SERVICE-INFO

Replacing tensioner lever 534 0062 20 in 534 0340 10 for Mercedes Actros

INA 0047

Image 1: 534 0062 20 (replaced design)

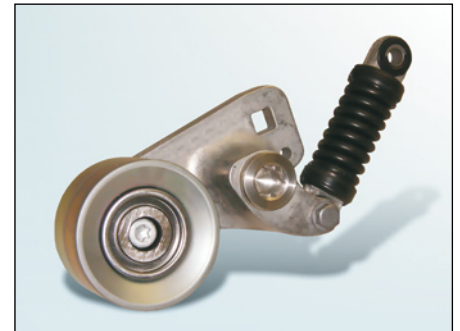
Tensioner lever 534 0062 20 (image 1) is no longer available and has been replaced by item no. 534 0340 10 (image 2).

The fundamental differences between the two designs are a new deflecting pulley with improved running characteristics and a modified shield plate.
